**SNUPPS**

SLNRC 84-0014 FILE: 0278  
SUBJ: Fire Protection Review

RESPONSES TO NRC FIRE PROTECTION

AUDIT CONCERNS

TYPICAL ELEVATION VIEW  
AUXILIARY BUILDING CORRIDOR  
CABLE TRAY SPRAY COVERAGE

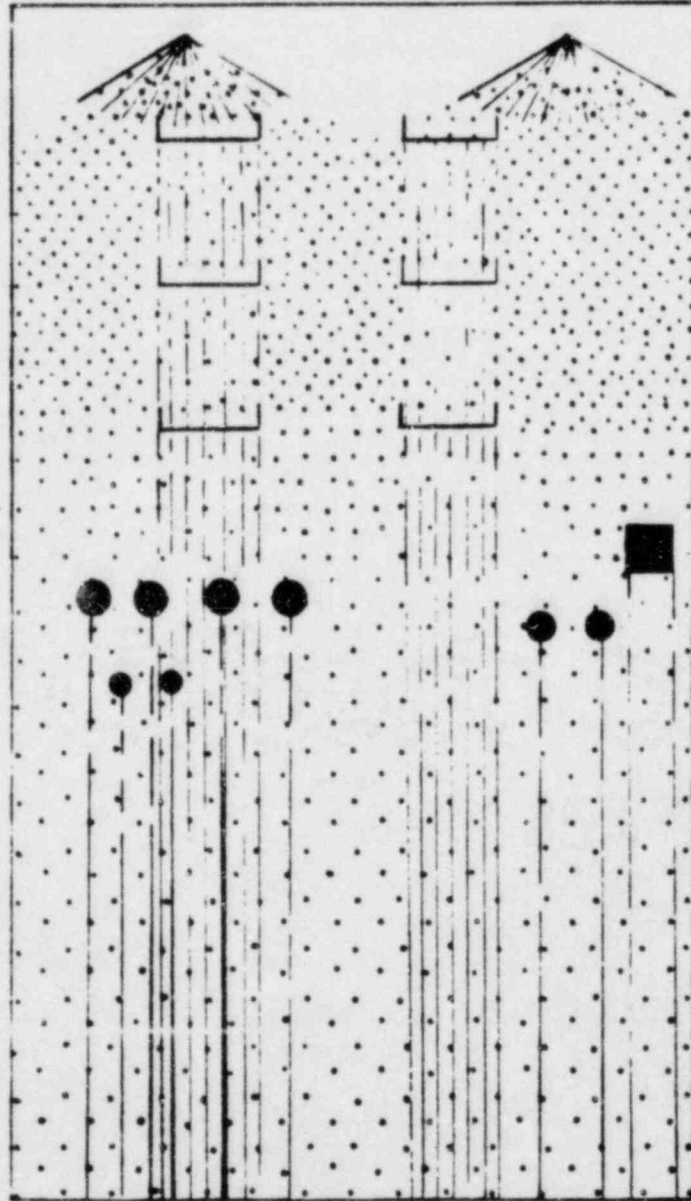
The NRC fire protection auditors indicated a general concern that certain auxiliary building corridors were too congested to allow the sprinklers located above cable trays to provide adequate coverage of the general floor area. Thus the cable trays were potentially lacking adequate protection from transient fires. The auditors suggested that additional sprinklers may be required below the lowest obstruction.

The concerns raised have been reviewed along with each auxiliary building corridor. Based on this review, it has been determined that no additional sprinklers are necessary. The following descriptions provide the bases for this determination.

The attached figure provides an elevation view of a typical corridor with two stacks of trays and a pictorial presentation of the head locations and sprinkler coverage. As shown the heads are located within inches of the ceiling and the 120° discharge cone of fine mist sized droplets pervades the cable tray area. The concentration of spray below the trays will be influenced by spray impingement on the walls, cable trays and any pipes which are present below the trays; however, due to the spray flow rate, the size of the droplets and turbulence due to the fire, a sufficient density of spray droplets will exist below the trays to control postulated transient fires until the fire brigade arrives.

Figure A

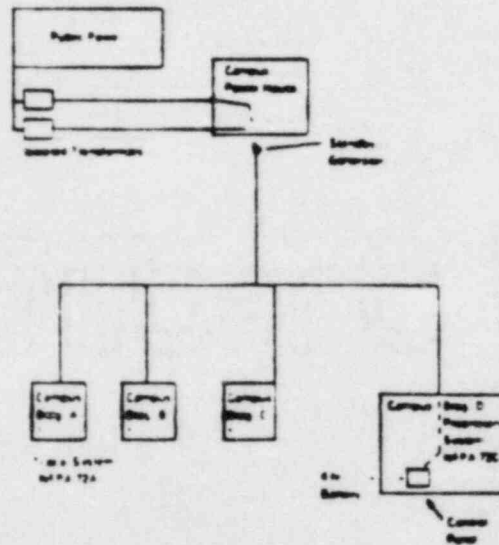
The basis for the NRC interpretation of NFPA 72D requiring the battery portion of the backup DC system to consist of 4 hour rated batteries located at the panels is an NFPA official interpretation dated August, 1977. This official interpretation was issued against the 1975 edition of NFPA 72D. A copy of this interpretation is included as Attachment A.

Regardless of the status of the subject O.I., the power source configuration questioned is not similar to that provided for SNUPPS. The O.I. system has a secondary source consisting of a standby generator serving all locations and 4 hr. batteries for only the main control panel. As indicated by Attachment B, all panels in the SNUPPS system can be powered by 125V batteries.

The O.I. specifies that given the indicated system power configuration, batteries with 4 hour capacity are required "at location A." Location A is a campus building not specifically a panel. The intent of this O.I. is to reiterate the requirement that remotely located control equipment/panels be provided with primary and secondary power supplies as detailed in NFPA 72D, section 2-6 (Article 220 of 1975 edition). Clearly, the system described in the O.I. does not meet the intent of this section since a battery source is provided only to the control panel and is not provided to the local systems. Failure of the standby generator upon loss of normal power will render the local systems out of service due to the lack of a DC battery source.

DETECTION SYSTEM POWER SUPPLY

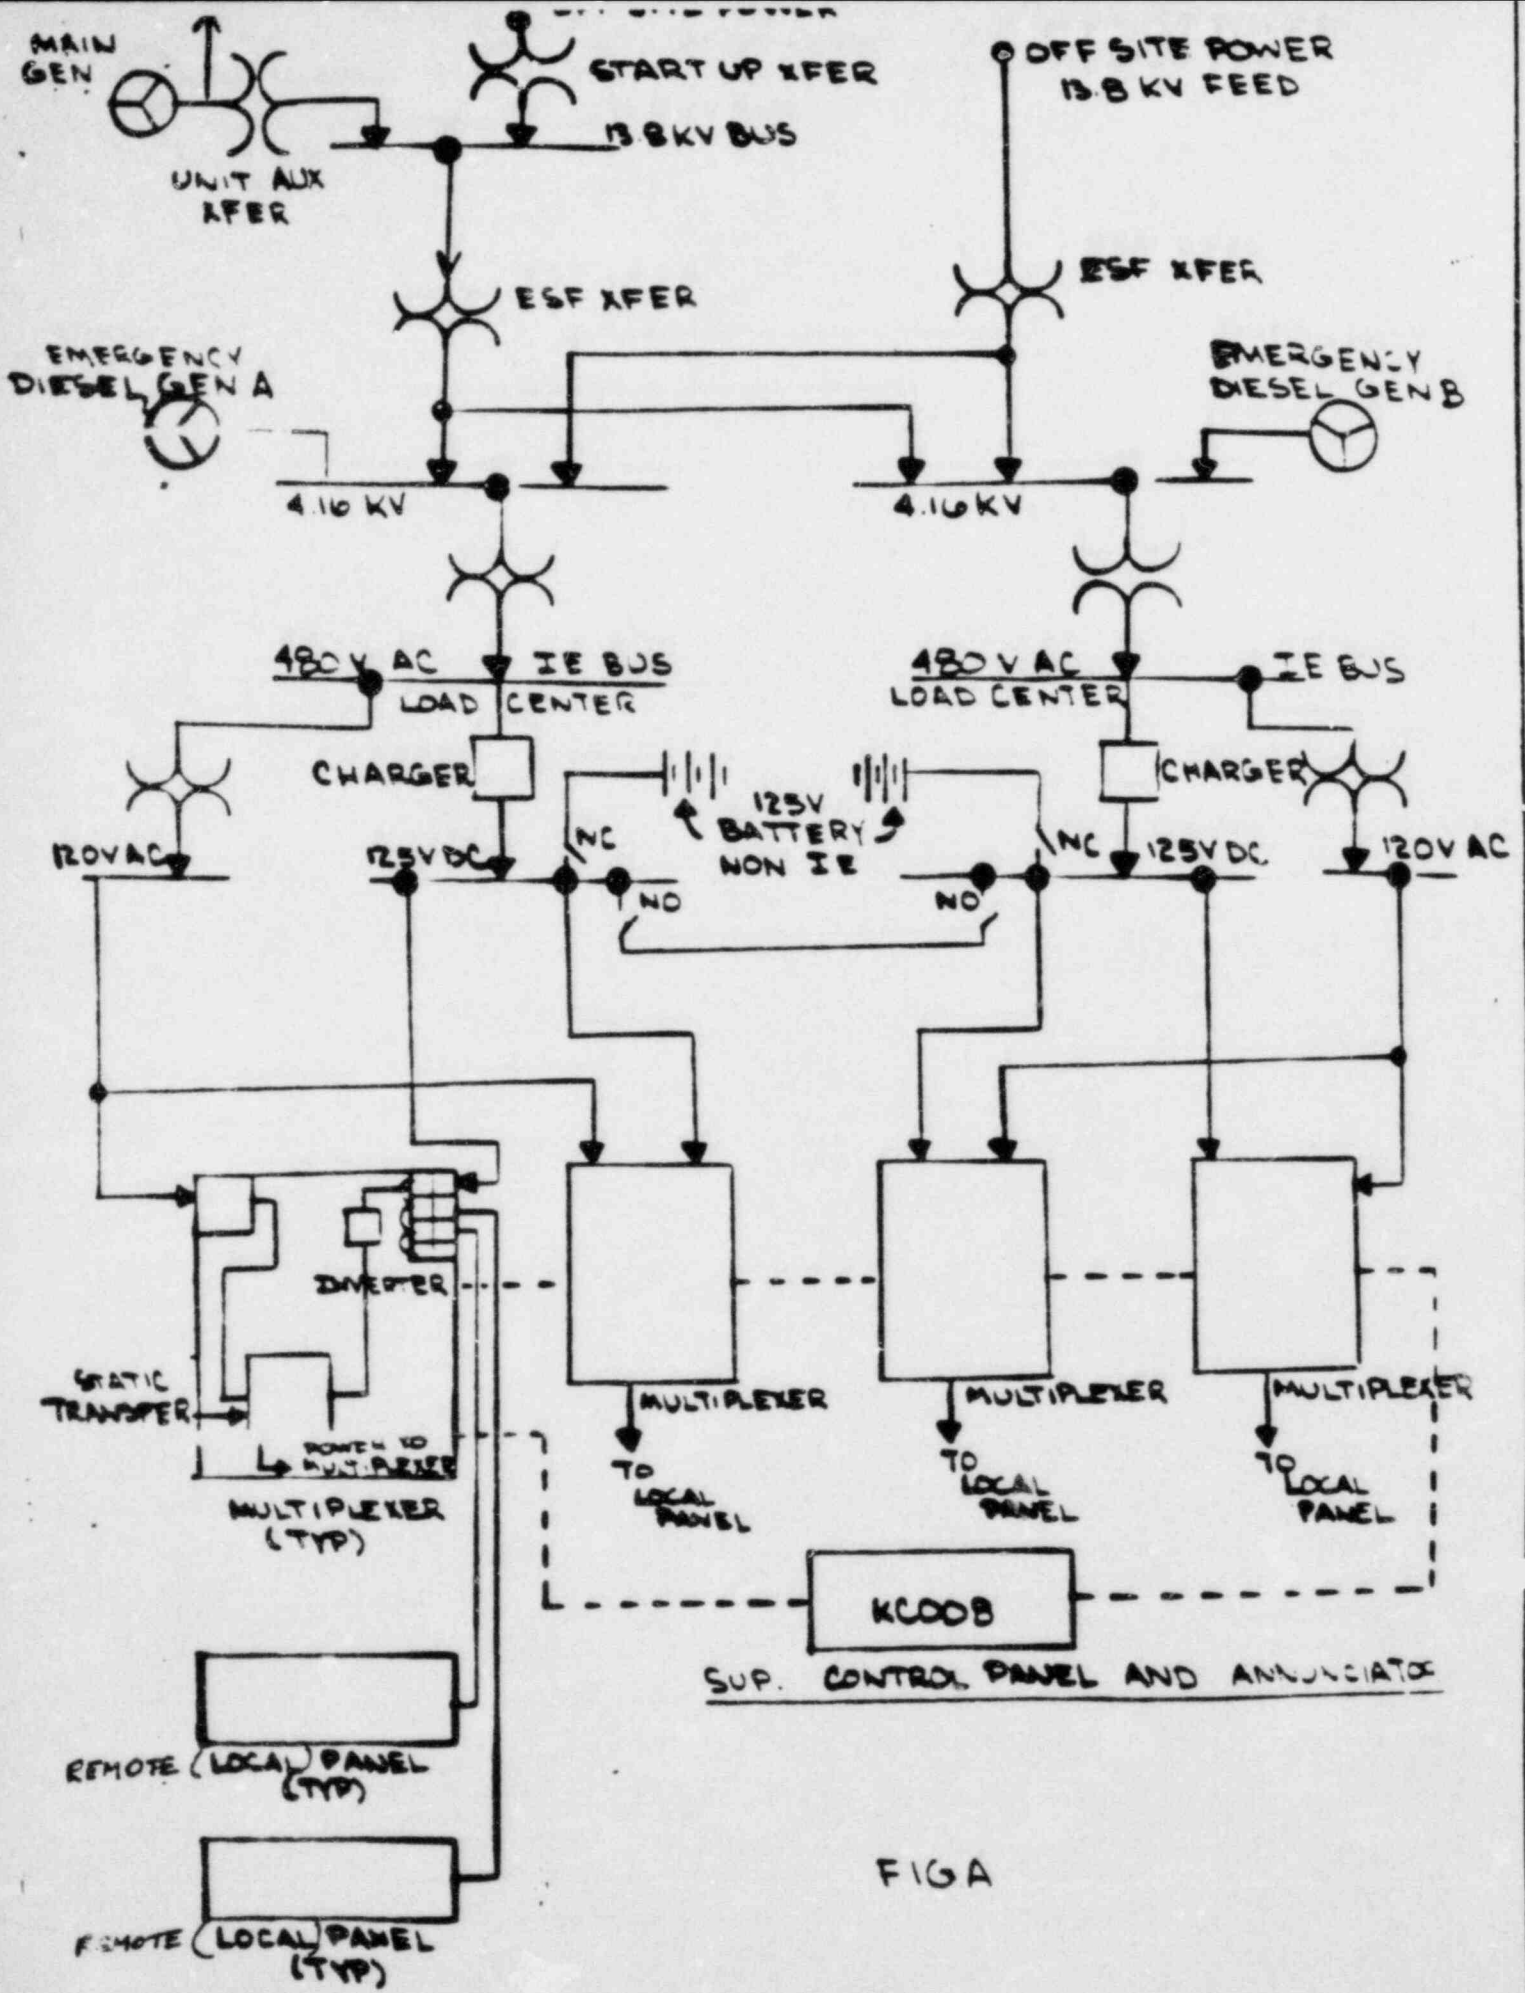
The NRC auditors indicated that the design of the SNUPPS protection system power supply was not in accordance with NFPA 72D and that standby power to remote fire protection panels and multiplexers should consist of 4 hr. rated batteries located at the panel.

The fire detection control panels provided for SNUPPS consist of four (4) multiplexers and multiple remote fire protection panels. The four multiplexers contain the systems transmitters/receivers which are in communication with a main annunciator/alarm panel. The remote fire protection panels provide the interface between suppression systems and the multiplexers. The following is an analysis of panel primary and backup power supplies. It serves as a basis for taking exception to the NRC interpretation of NFPA 72D requiring that the backup DC system consist of 4 hour rated batteries located at the local panels. A sketch of the power source arrangement is attached (Attachment B).
